ADDENDUM NO. 1

April 12, 2021

HANOVER CENTRAL HIGH SCHOOL ADDITIONS AND RENOVATIONS Cedar Lake, IN 46303

3
A-503

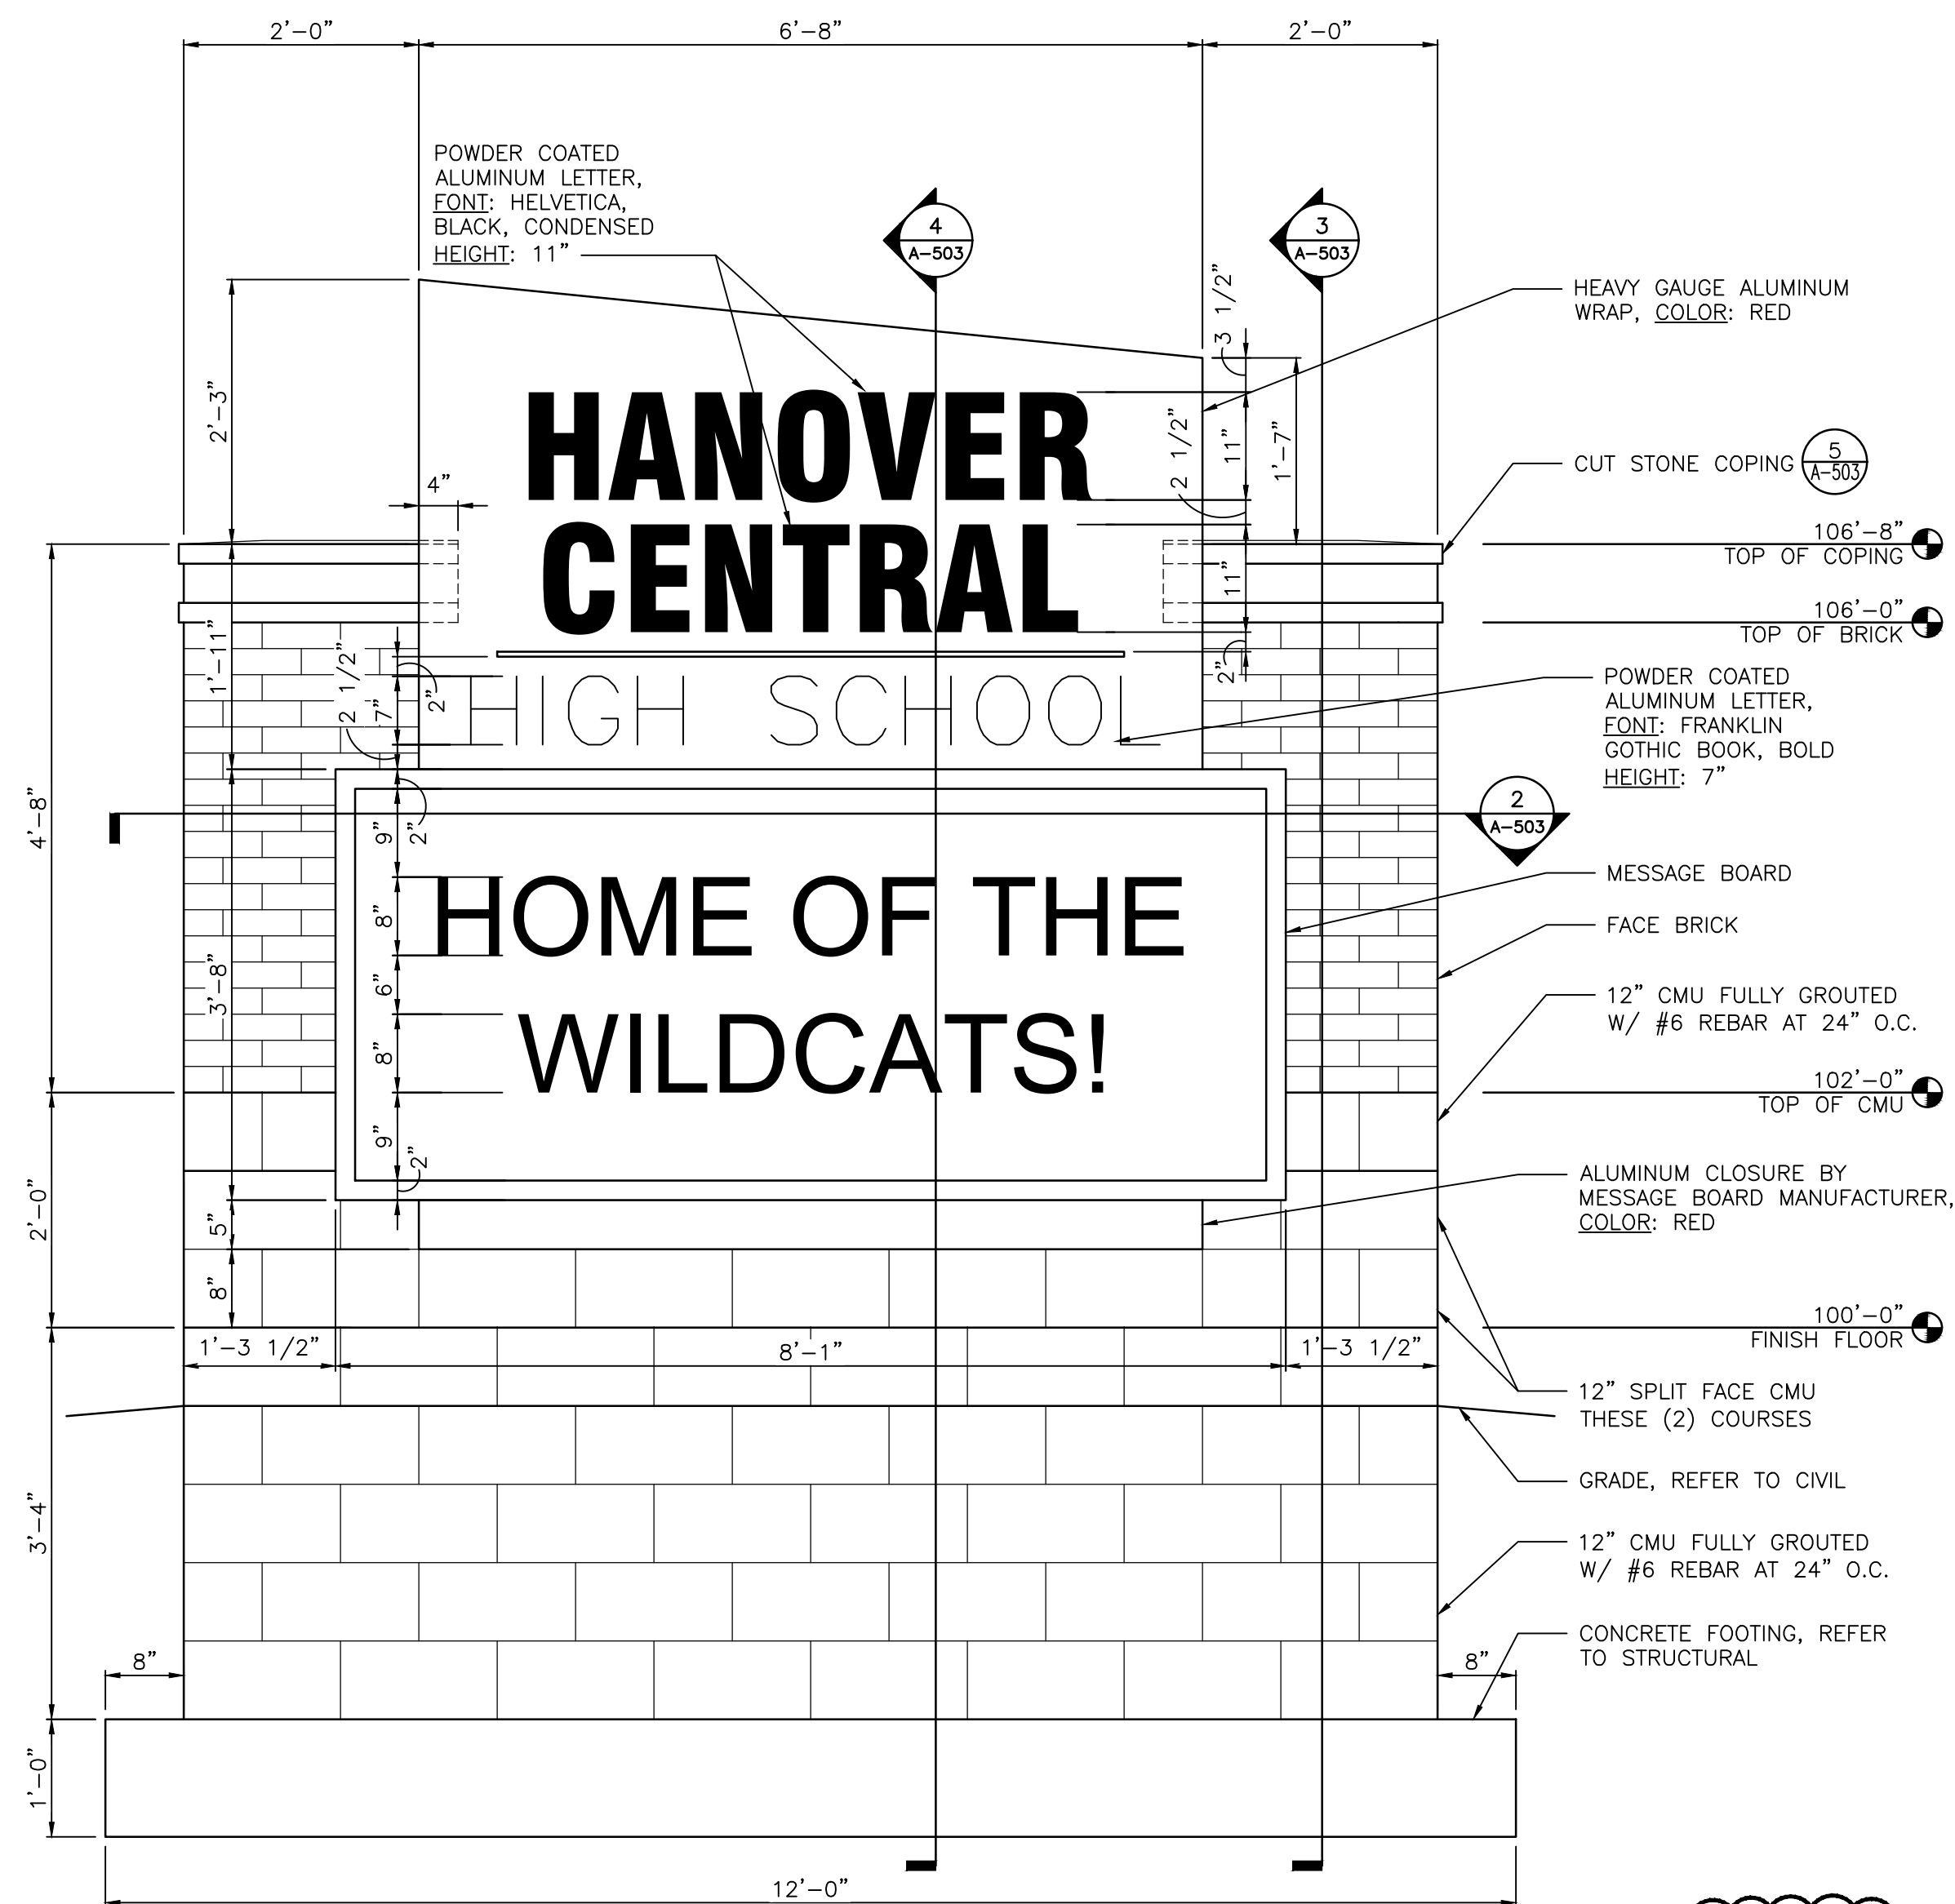
- A. Add new Sheet A-503, included in this Addendum, to the Project Documents.

© GIBRALTAR DESIGN	SHEET
B	P-112

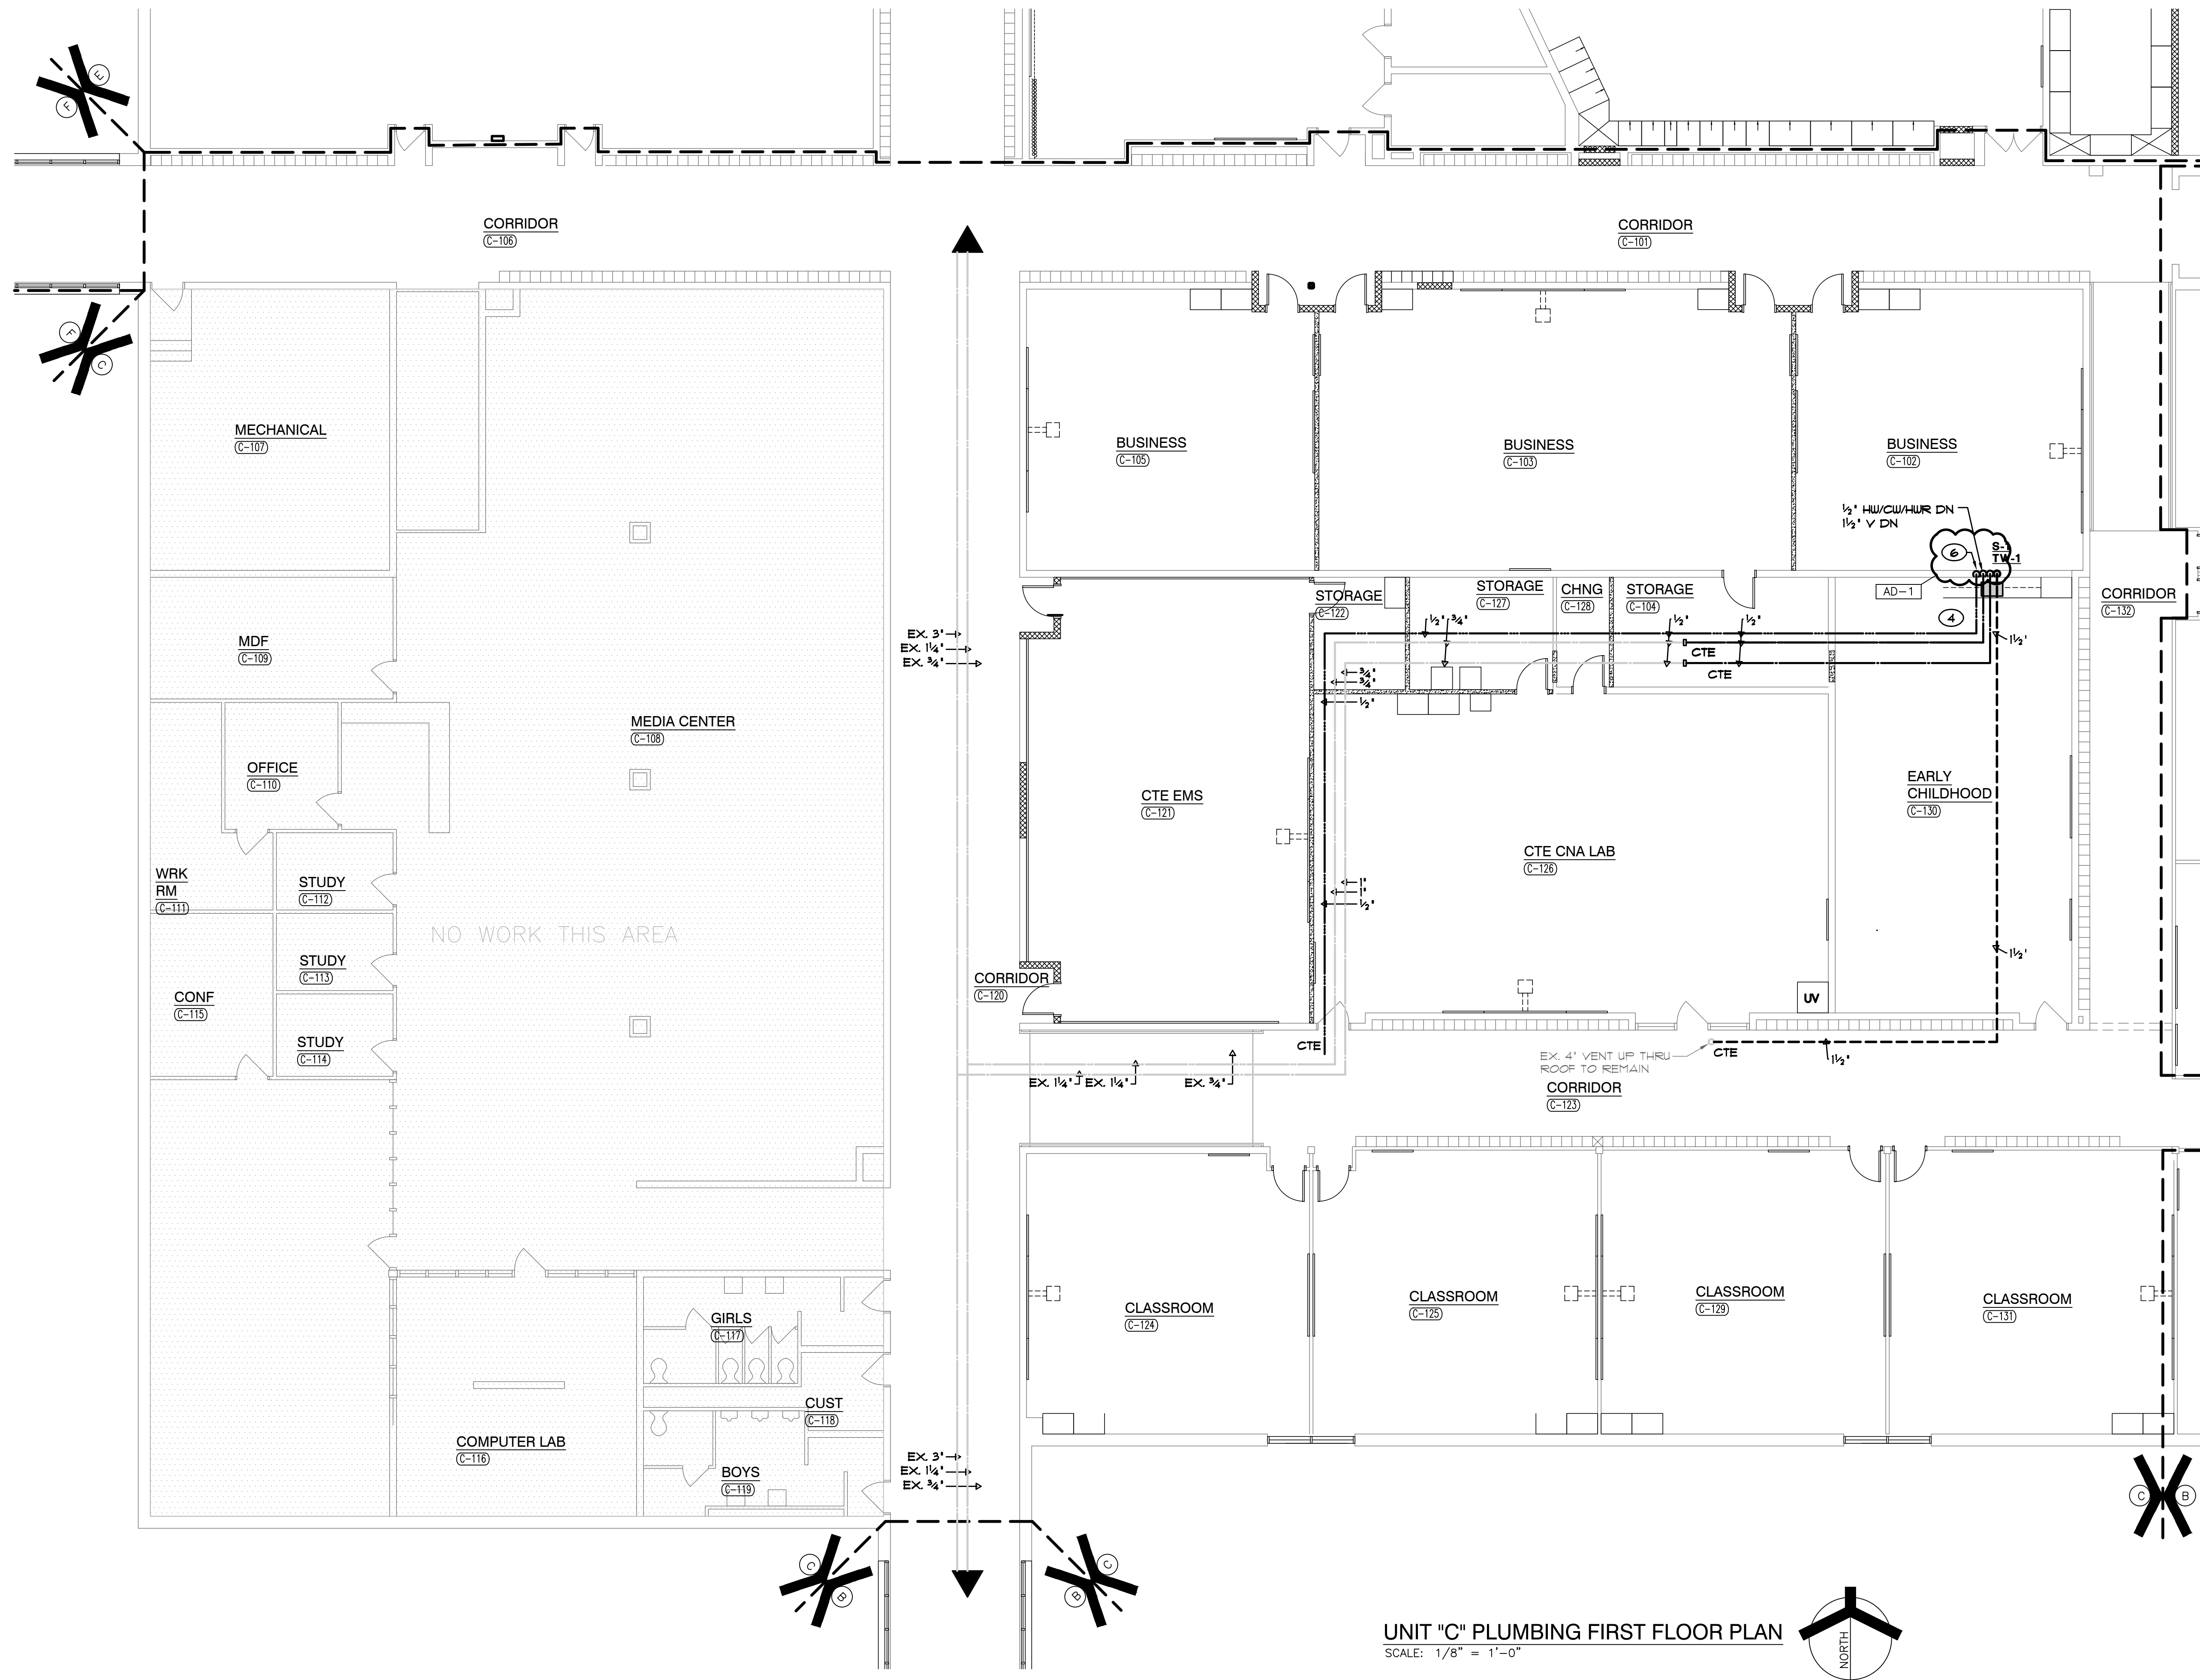
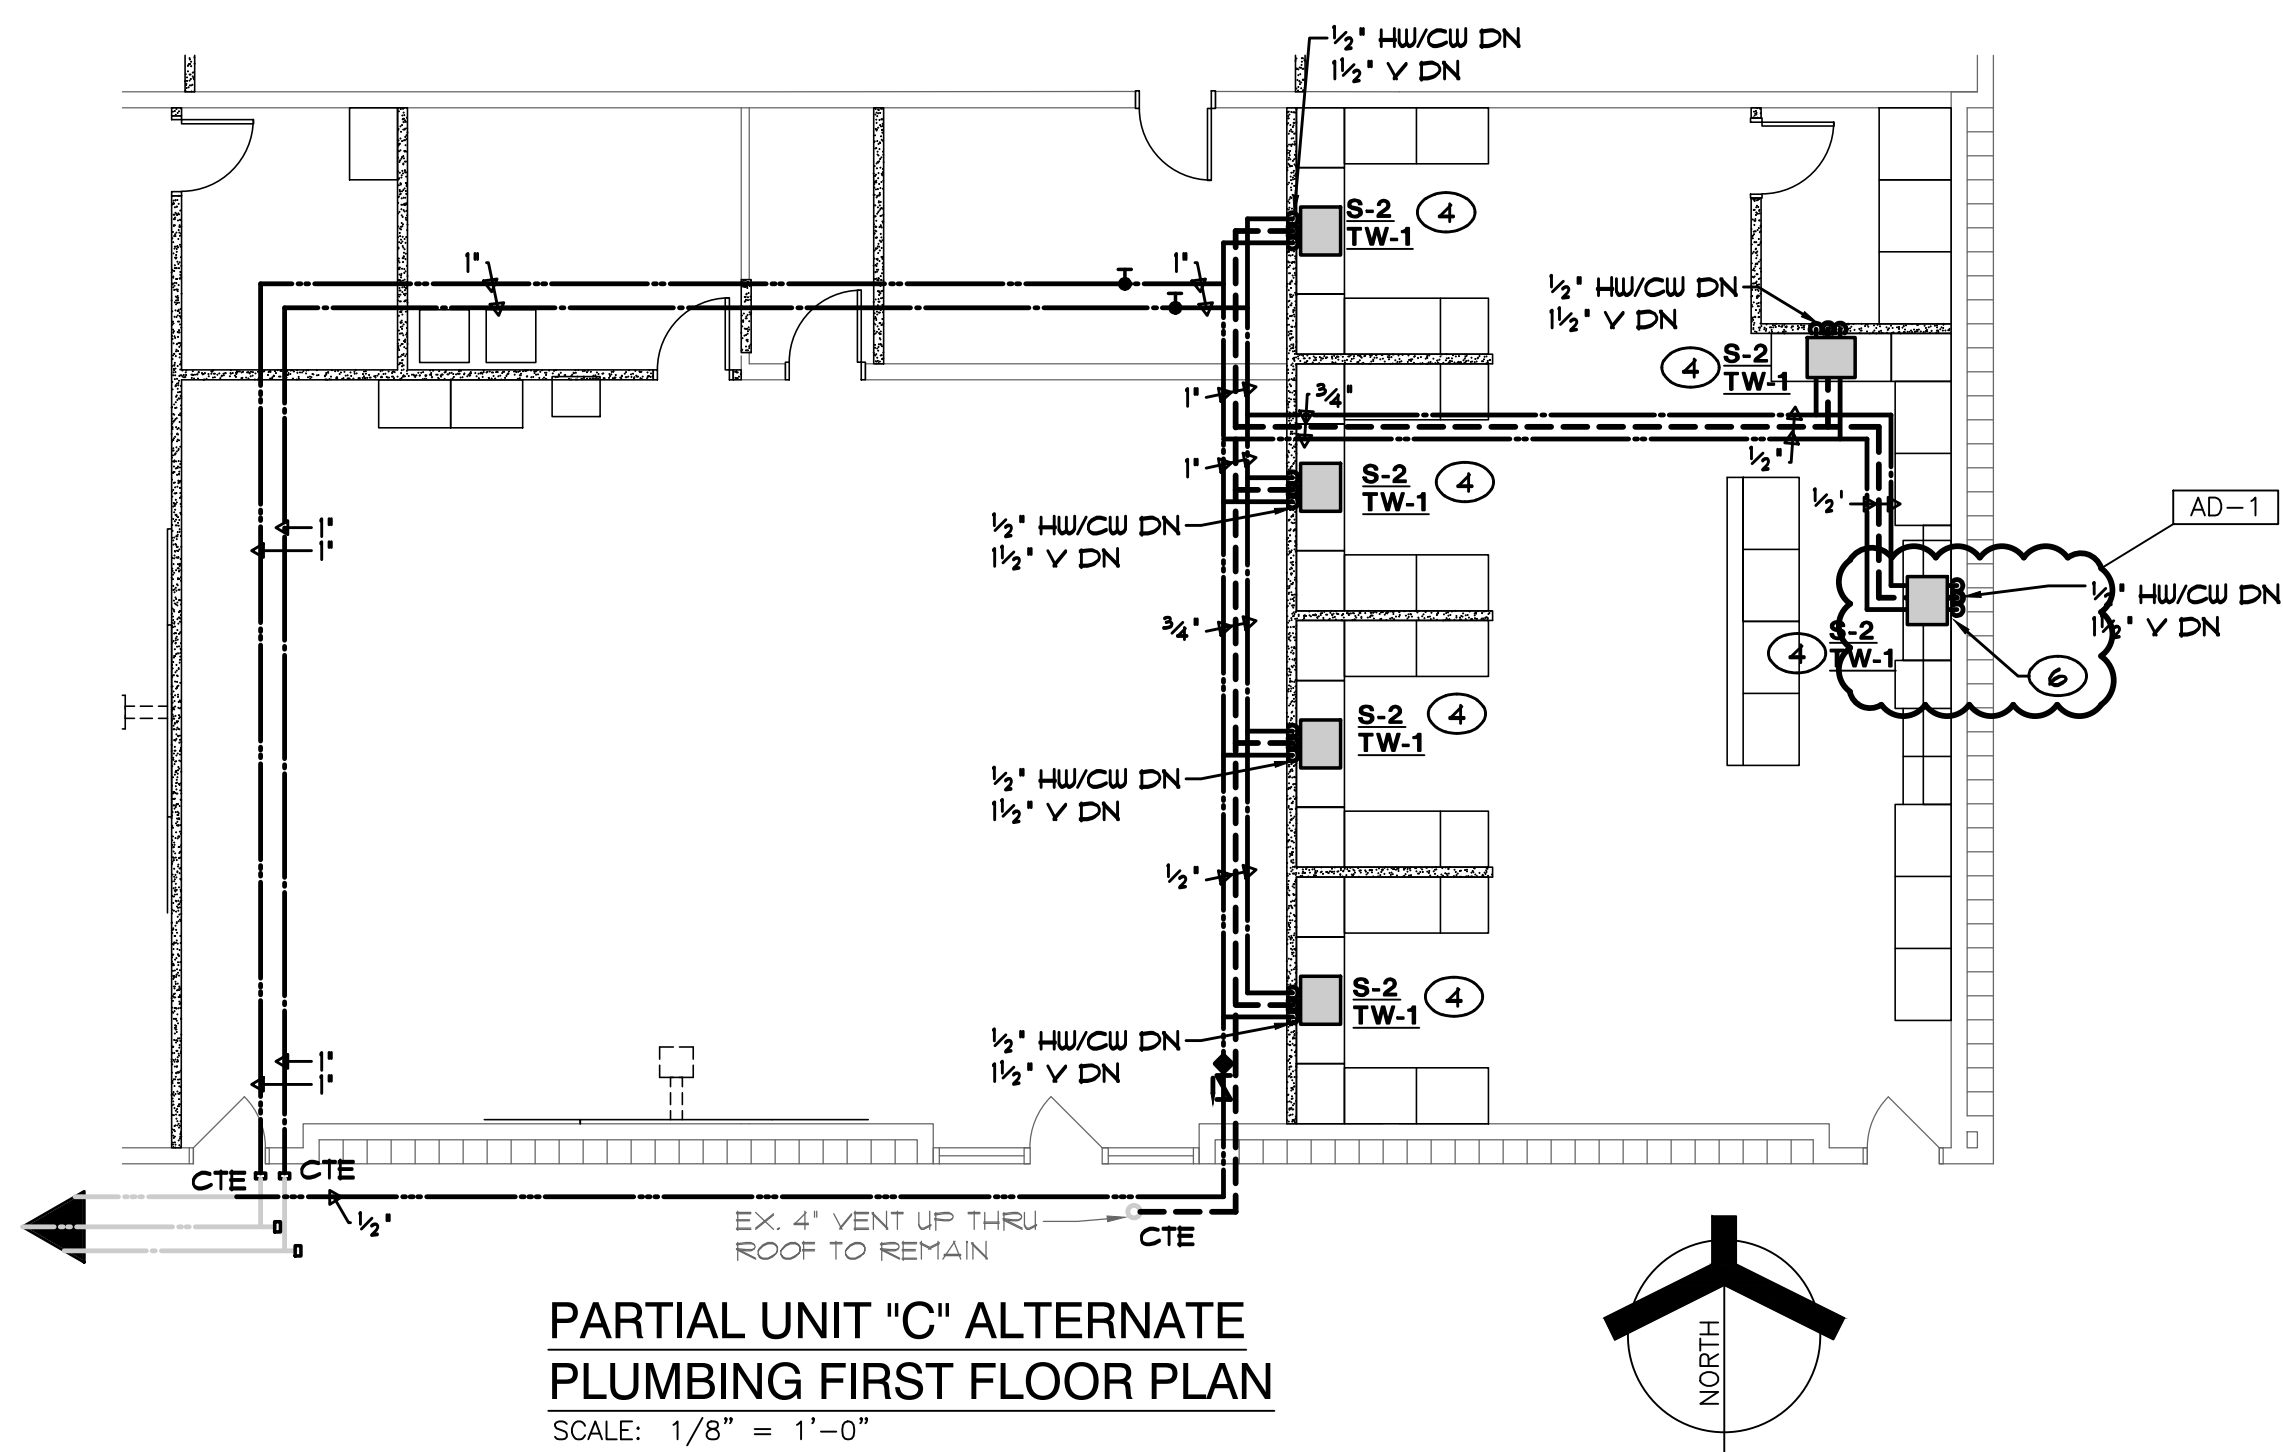
- A. Refer to revised full-size drawing, included in this Addendum, for the following revisions.
 1. Added hot water return piping.
